Form Number: 160.46-OM3.1 (LS15)	1104
	Supersedes: 160.46-OM3.1 (SB9 & SB11)	
LITERATURE SUPPLEMENT	File with: 160.46-OM3.1 (1191)	
Subject: Liquid Cooled Starter Nuisance 1/2 Phase trips

FIG. 1 - SOLID STATE STARTER (STYLE A) LOGICBOARD

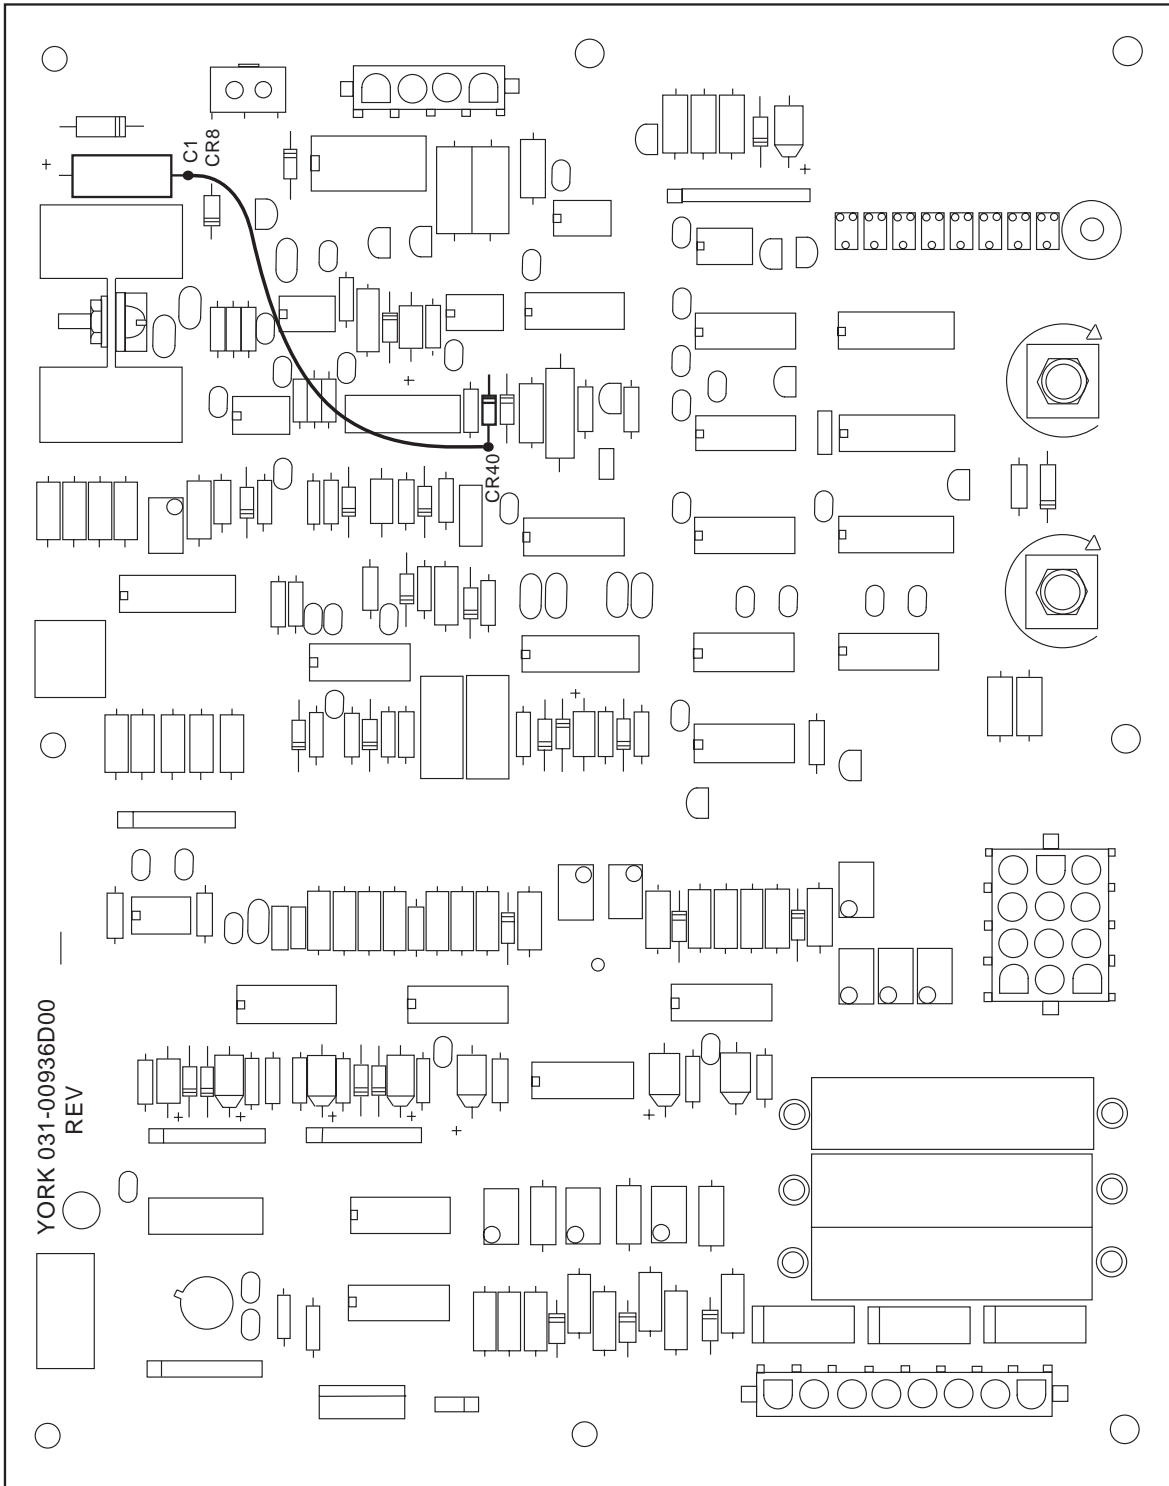
If tripping is caused by one of these conditions, it would be best to correct the problem at the source, i.e. change transformer taps to lower voltage, put filters on VSD's, or balance out single phase loads to bring voltage balance to within 1%. If this is not possible, you may have no choice but to eliminate the 1/2 phase circuit. **On older rev. 'D' through rev. 'F' boards, you will need to solder a wire jumper as shown on Fig. 1. On (Rev G) and newer starter logic boards, there is a jumper wire, JP1, located approximately 1.5 inch below the large black heatsink in the upper right corner. Cut this jumper to disable the 1/2 phase circuit.**
